CITY OF CODY
PLANNING, ZONING AND ADJUSTMENT BOARD
TUESDAY, JULY 14, 2020
CITY HALL COUNCIL CHAMBERS @ 12:00 NOON

**CITY OF CODY
PLANNING, ZONING AND ADJUSTMENT BOARD
STAFF REPORT**

MEETING DATE:	JULY 14, 2020	TYPE OF ACTION NEEDED	
AGENDA ITEM:		P&Z BOARD APPROVAL:	X
SUBJECT:	SITE PLAN REVIEW: LEGACY ENTERPRISE STORAGE UNITS SPR 2020-16	RECOMMENDATION TO COUNCIL:	
PREPARED BY:	TODD STOWELL, CITY PLANNER	DISCUSSION ONLY:

MEETING DATE:	JULY 14, 2020	TYPE OF ACTION NEEDED	
AGENDA ITEM:		P&Z BOARD APPROVAL:	X
SUBJECT:	SITE PLAN REVIEW: BUFFALO BLUFF RV PARK. SPR 2020-15	RECOMMENDATION TO COUNCIL:	
PREPARED BY:	TODD STOWELL, CITY PLANNER	DISCUSSION ONLY:

PROJECT: DANA SANDER
TITLE: 601 14th STREET SITE GRADING PLAN

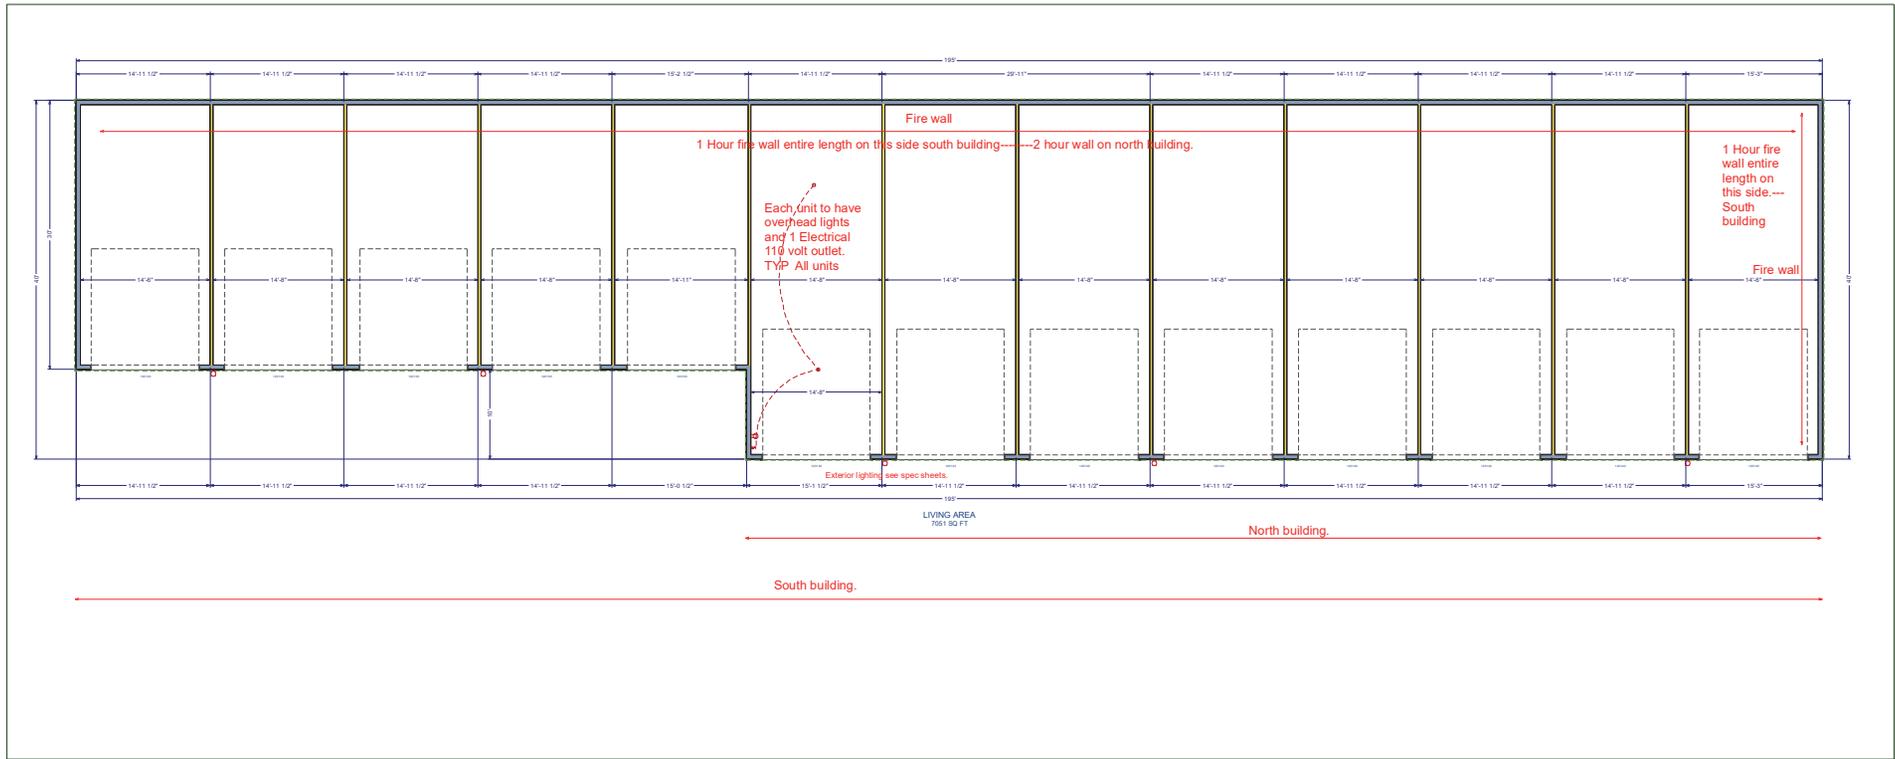
An engineered storm water plan has been prepared to address runoff according to the City's storm water policy manual. However, the report is only a draft report from 2017 and is not fully coordinated with the current site plan and architecture (i.e. building shifted and roof changed from gable to single-slope). The concepts of the report are standard practice—using gutter systems and infiltration trenches to collect and infiltrate the required amount of storm water. The engineer will need to update the report based on the current situation. Staff would also recommend that the infiltration area for the north building be moved further from the slope, so as to further minimize the potential for destabilization of the hillside.

1. Prior to issuance of a building permit, provided an updated storm drainage report/grading plan for review and approval by City staff.
2. Prior to issuance of a building permit, coordinate the electrical service plan with the City (one service or two, etc.)
3. Modify the exterior lighting plan to the extent specified by the Planning and Zoning Board (at a minimum adjust spacing, and potentially reduce all or some fixtures to the 20-watt version).
4. Change the "Insulated Thickened Edge Slab" detail on Sheet D-1 to read "Place at least 15 feet from edge of hill" instead of 10 feet, and following the revised plan.

CONCRETE FOUNDATION

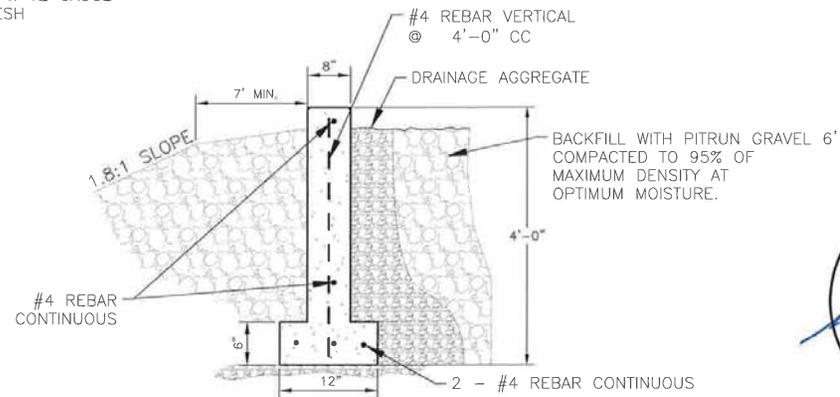
In addition, the building code has a setback requirement from the hillside of 15 feet, which can be reduced based on engineering/geotechnical analysis. While the plans recognize this concept and propose an increased footing depth of four feet near the hillside, the length of the deeper footing needs to be extended so that it is used instead of the thickened edge slab at any point within 15 feet of the edge of the slope, or an engineering analysis of slope stability would need to be provided to demonstrate otherwise. The change is as simple as changing the "Insulated Thickened Edge Slab" detail on Sheet D-1 to read "Place at least 15 feet from edge of hill" instead of 10 feet, and following the revised plan.

NOTE: PLACE AT LEAST 10' FROM EDGE OF HILL

C2.2
 SHEET 5 OF 11

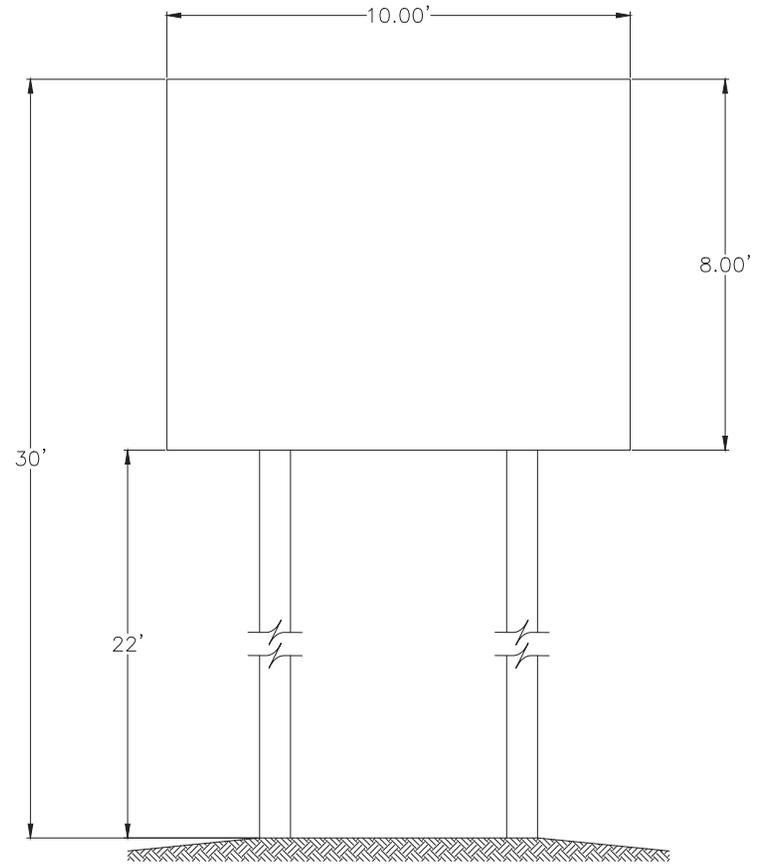
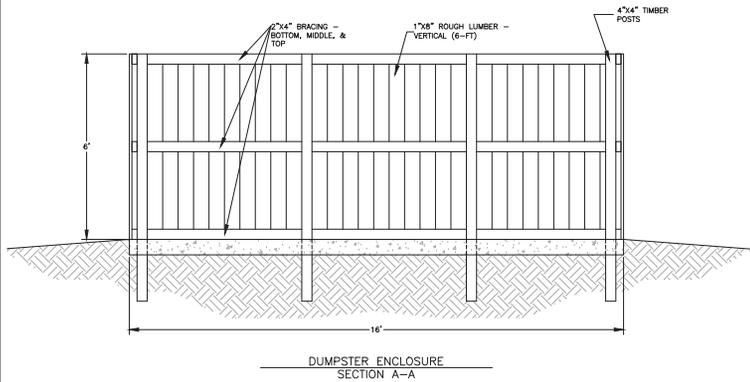
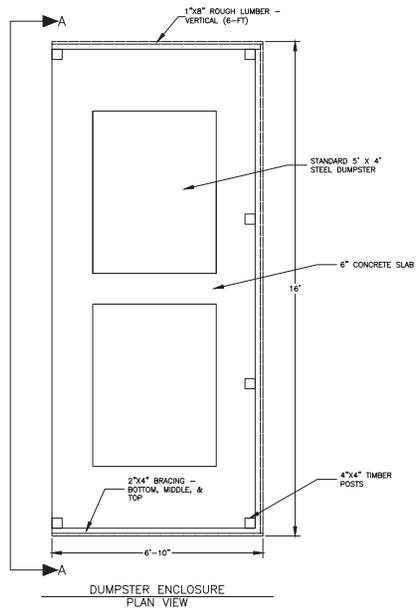
The applicant is negotiating a development agreement with the City involving the extension of City sewer and City power to the site. Looking at Sheet 5, the sanitary

sewer easement running generally east-west will contain an 8" City sewer line. All other sewer within the park will be private. The internal sewer plans have been submitted to WY DEQ for approval. The City is agreeable to the locations proposed. However, it is noted that the slopes of some of those sewer lines are less than the plumbing code permits for the size of line proposed. Minimum slope for a 6" sewer line is 1/16" per foot (approx. 1%). Minimum slope for 8" pipe is half that. The required slope can be provided by either increasing pipe size, or deepening the main and/or increasing slope. The current plan maintains a depth of at least 4 feet, which is typically required for year-round sewer service for freeze protection reasons, yet staff would be agreeable to shallower sewer lines due to the fact that the RV park will only operate in the warmer times of the year.

The electrical plan with colored lines is the correct electrical layout (not the layout shown on Sheet 5).

D2.0
SHEET 10 of 11

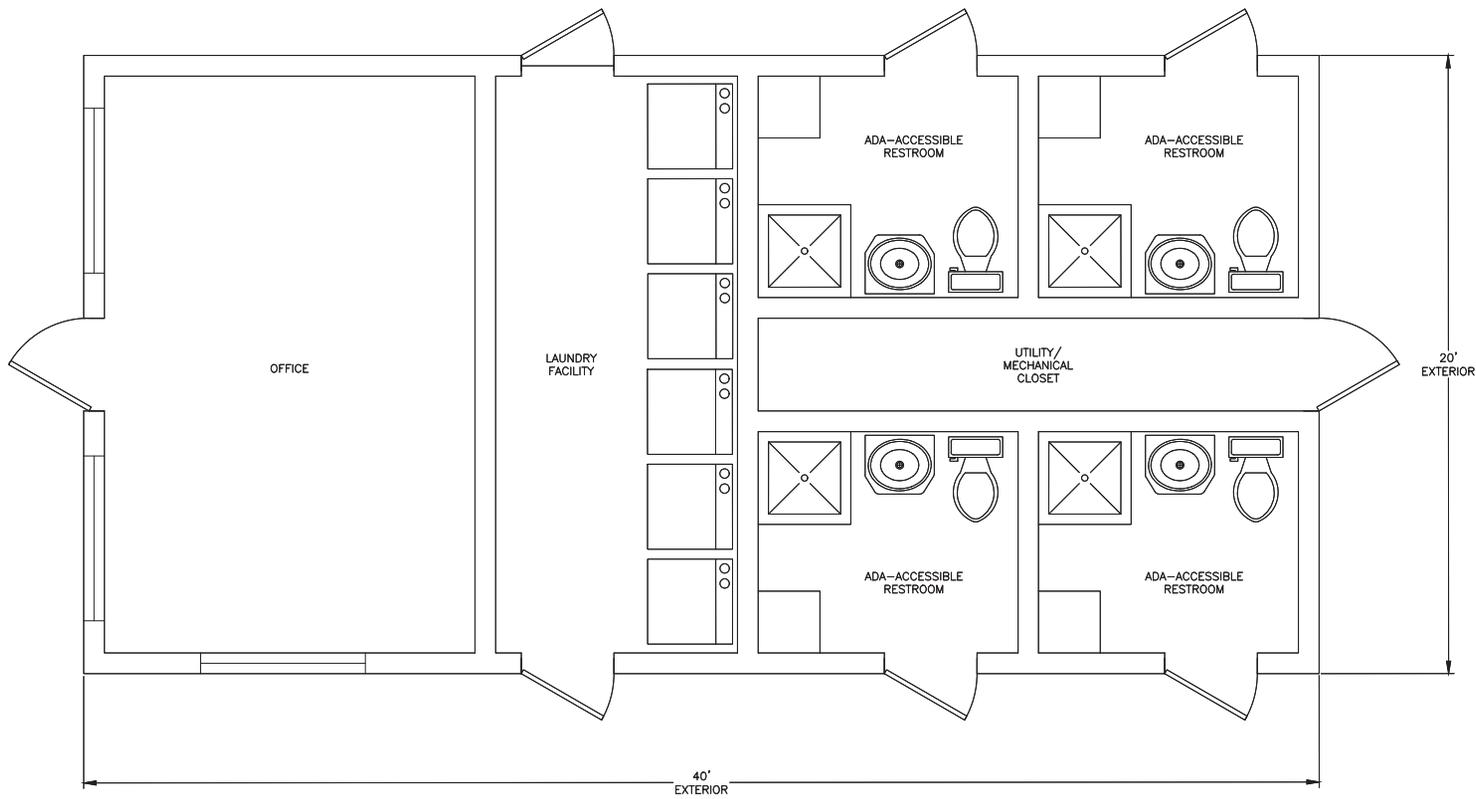
The only architecture relates to the building serving as the office/laundry/restrooms. It can be seen on Sheet 10 and 11 of the plans. It is noted that the plans show a single-sloped roof. However, due to the resulting 15-foot wall height, it would trigger engineering. The applicant is considering a different roof design on 10-foot tall walls. The siding would be typical horizontal metal siding. Roof material is not identified. If the roof design is modified to a standard gable or hipped design, the building would lose some of its architectural appeal. A design similar to the one shown here may be a good option and avoid the engineering.
